SUBJECT: AMENDMENT NO. 98 TO FACILITY OPERATING LICENSE NO. NPF-3

DAVIS-BESSE NUCLEAR POWER STATION, UNIT NO. 1

AMENDMENT TO FACILITY OPERATING LICENSE

SAFETY EVALUATION BY THE OFFICE OF NUCLEAR REACTOR REGULATION  
SUPPORTING AMENDMENT NO. 98 TO FACILITY OPERATING LICENSE NO. NPF-3  
TOLEDO EDISON COMPANY  
AND  
THE CLEVELAND ELECTRIC ILLUMINATING COMPANY  
DAVIS-BESSE NUCLEAR POWER STATION, UNIT NO. 1  
DOCKET NO. 50-346

6.2.1 The offsite organization for facility management and technical support shall be as shown on Figure 6.2-1.

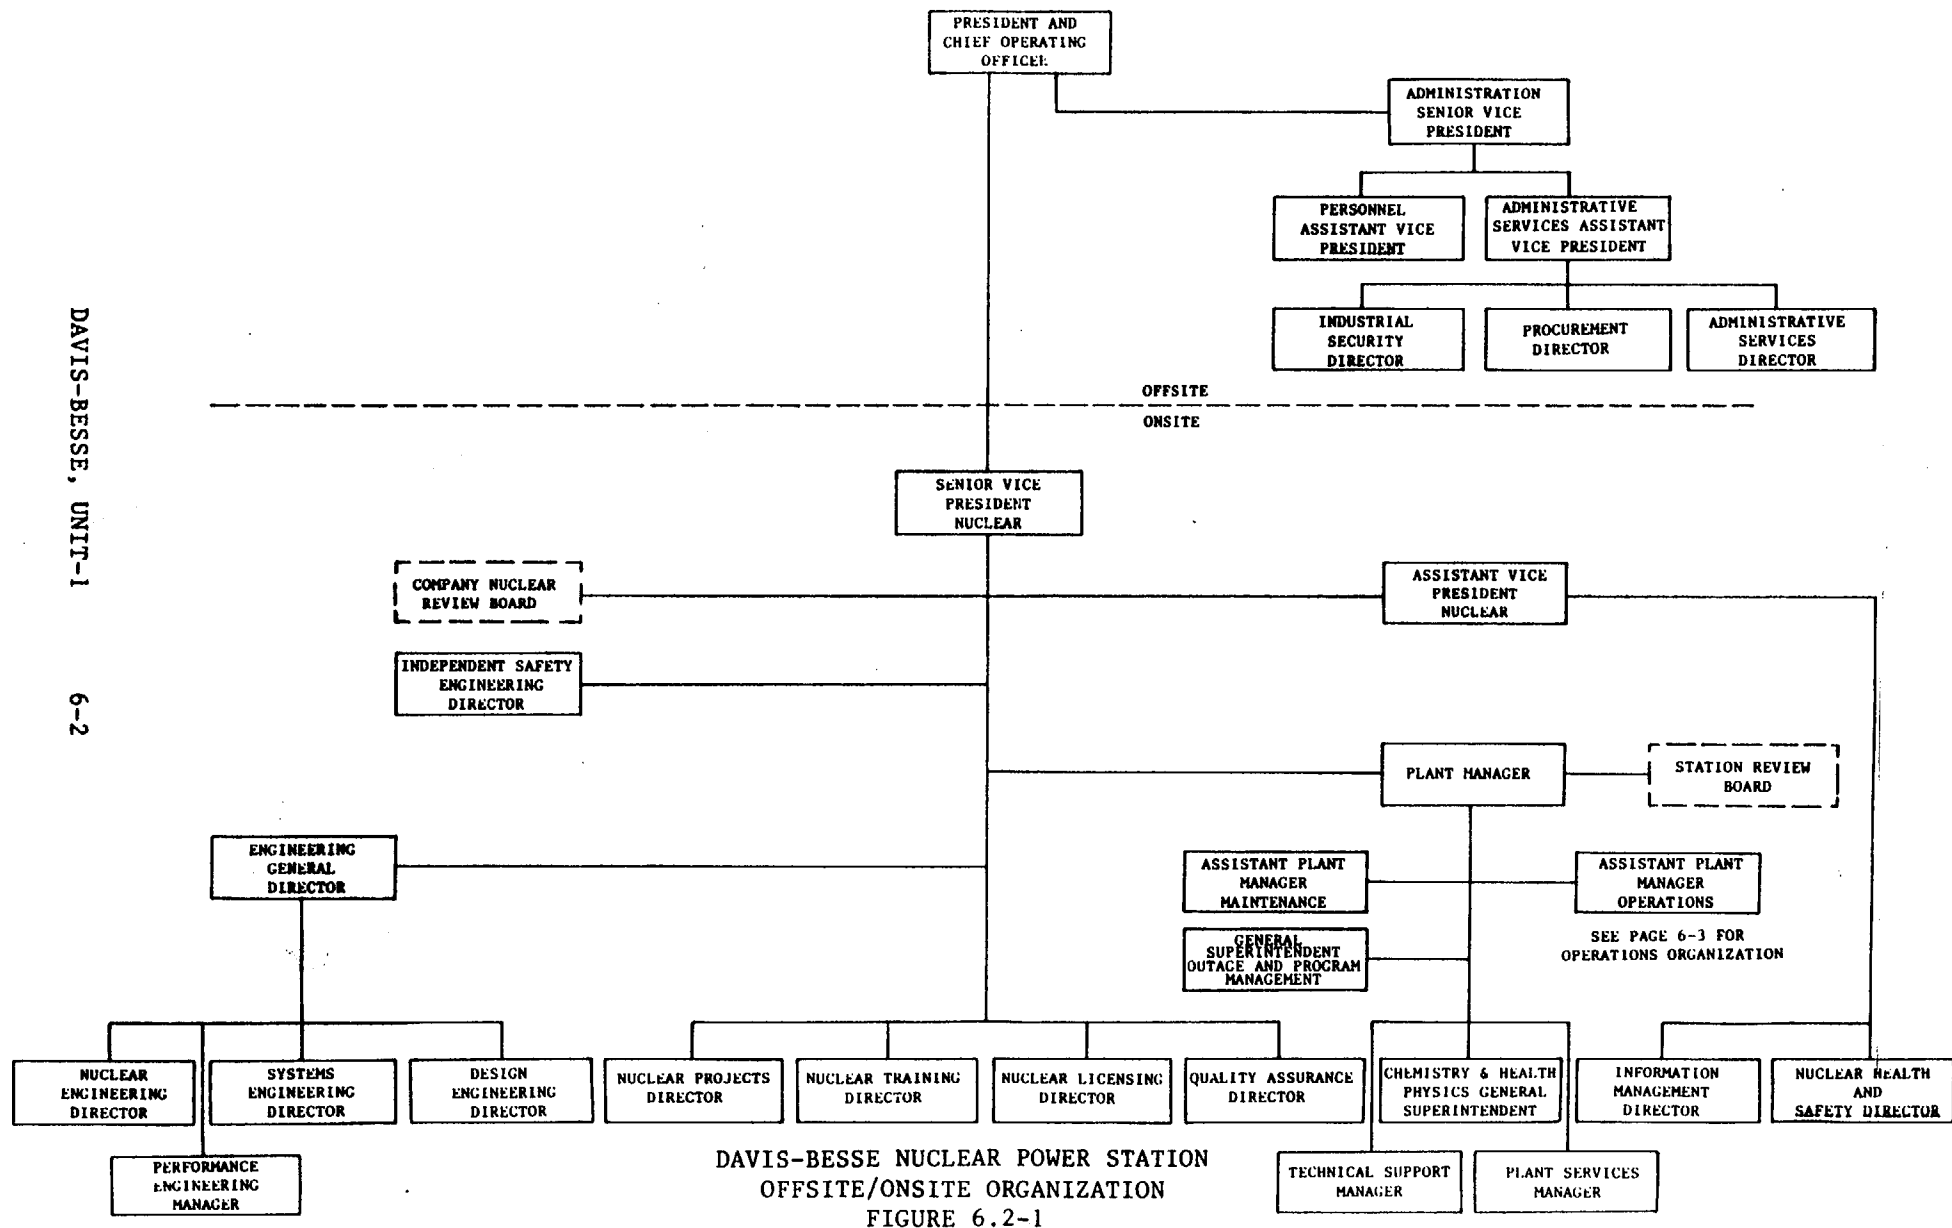
Other organization title changes shown in the revised Figure 6.2-1 change the title of Station Superintendent to Plant Manager. The Assistant to the Vice President, Nuclear, is changed to Assistant Vice President, Nuclear; Administrative Service Vice President to Administration Senior Vice President; Assistant Plant Superintendent Operations to Assistant Plant Manager, Operations; Assistant Station Superintendent Outage Management to General Superintendent Outage and Program Management; the Chemist and Health Physicist to Chemistry and Health Physics General Superintendent; Technical Engineer to Technical Support Manager; Nuclear Facility Engineering Director to Engineering General Director; Nuclear Licensing Manager to Nuclear Licensing Director; and the Nuclear Training Manager to Nuclear Training Director.

The revisions to Figure 6.2-1 also include the following new positions:

- ° The Administrative Services Assistant Vice President and the Personnel Assistant Vice President report to the Administration Senior Vice President.
- ° The Independent Safety Engineering Director reports to the Senior Vice President, Nuclear.
- ° The Nuclear Health and Safety Director and the Information Management Director report to the Assistant Vice President, Nuclear.
- ° The Assistant Plant Manager, Maintenance, reports to the Plant Manager.
- ° The Nuclear Engineering Director, Performance Engineering Manager, Systems Engineering Director, and the Design Engineering Director report to the Engineering General Director.

In addition to title changes and the realignment of responsibilities, the reorganization changes the level of some of the positions. The following positions have moved higher in their reporting status which is considered an overall enhancement:

- ° The Nuclear Training Director and the Nuclear Licensing Director now report directly to the Senior Vice President, Nuclear.
- ° The Technical Support Manager and Chemistry, Health Physics General Superintendent and Assistant Plant Manager, Maintenance, now report directly to the Plant Manager.
- ° The Shift Supervisor now reports directly to the Operations Superintendent.

The following positions have moved lower:

- ° The Environmental Activities and Emergency Planning Group now report to the Nuclear Health and Safety Director, a new position that reports to the Assistant Vice President, Nuclear.

This removes the groups one step from the Senior Vice President, Nuclear, but preserves their independence from line management.

The NRC staff has reviewed the above changes and concludes that the organizational changes in most cases eliminate organizational steps to the President and enhance the position status. In the cases where the positions were moved one step further from the President, the positions' independence from the line organization was maintained. The staff concludes that the organization shown in Figures 6.2-1 and 6.2-2 is acceptable.
